From: Danny Mapili - WPD-C
To: Joshua Hill
Cc: Kaan Dilber; Terry Lamb Sr.; Todd Williams; Patrick J. Murray; Edwin Lopacki - WPIB; Andrea Mango
Subject: Re: FERC Swing: Status of Design Review
Date: Tuesday, July 19, 2016 5:33:20 PM
Attachments: image001.png

I would like to check the status of the Design Review for the 100%CD's FERC Swing.

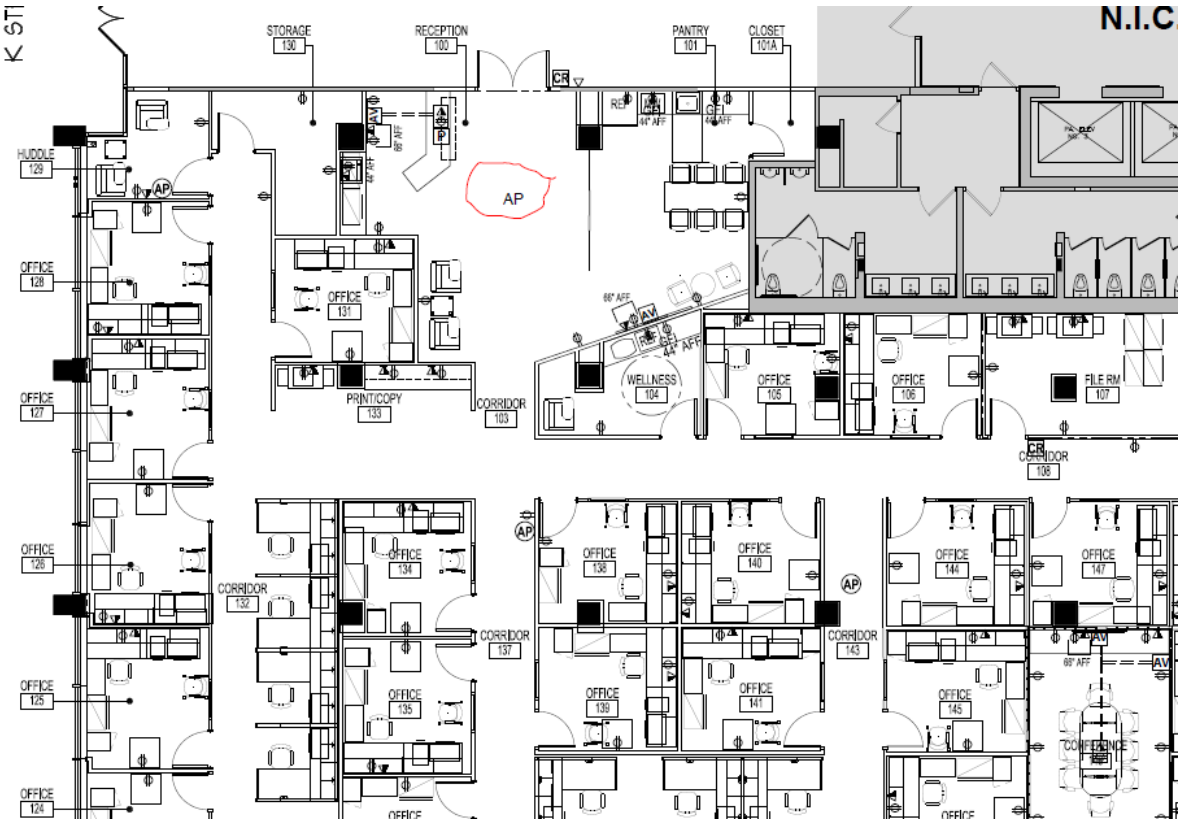
1. Additional wireless Access point (there's also a drawing embeded in the email showing this location)

> Danny,
>
> Below are our comments:
>
> On A301, we may need an additional wireless access point located in the vicinity of the entrance to the suite (see drawing below).
>
> Also, I do not see where the low-voltage cabling is included anywhere, either in the drawings or specifications. We had discussed this being included in the construction work.
